# EFFECT OF BUS\_SET\_DELAY ON MAXIMUM DOMAIN DELAY

T10/97-116r0

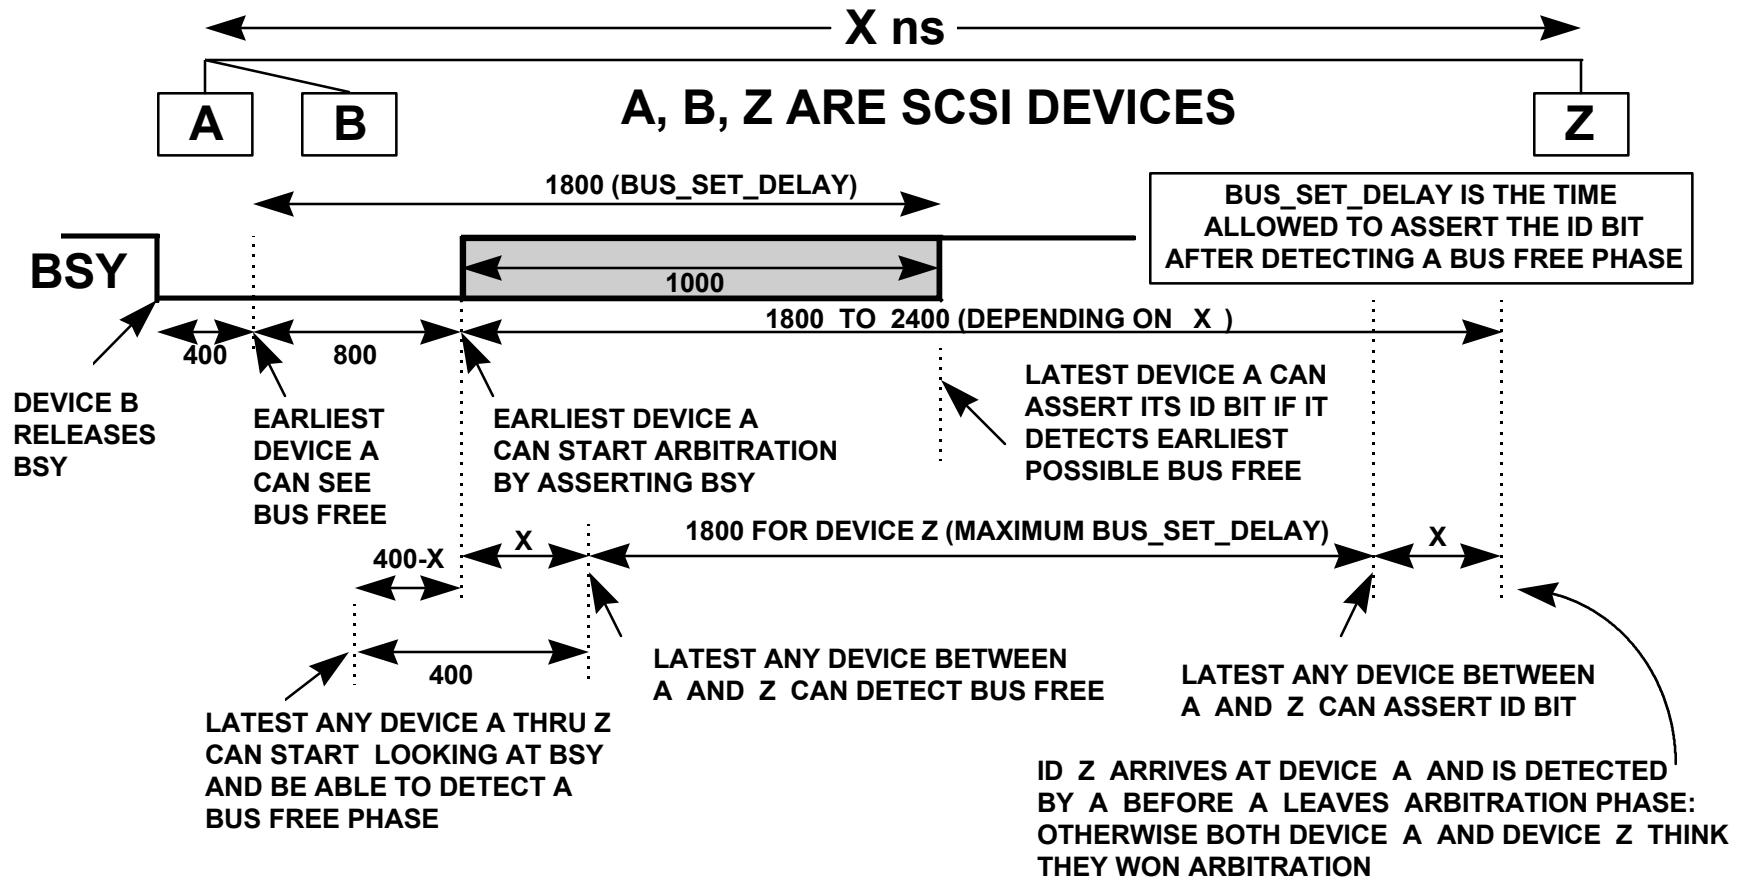
**WORST CASE UNDER ABOVE ASSUMPTIONS:  $2X + 1800 = 2400 \Rightarrow X = 300$  ns**

**NEED TO REDUCE MAXIMUM BUS\_SET\_DELAY TO 1600 ns OR LESS IN ORDER TO RECOVER THE FULL 400 ns PROPAGATION TIME ALLOWED BY THE BUS SETTLE DELAY**
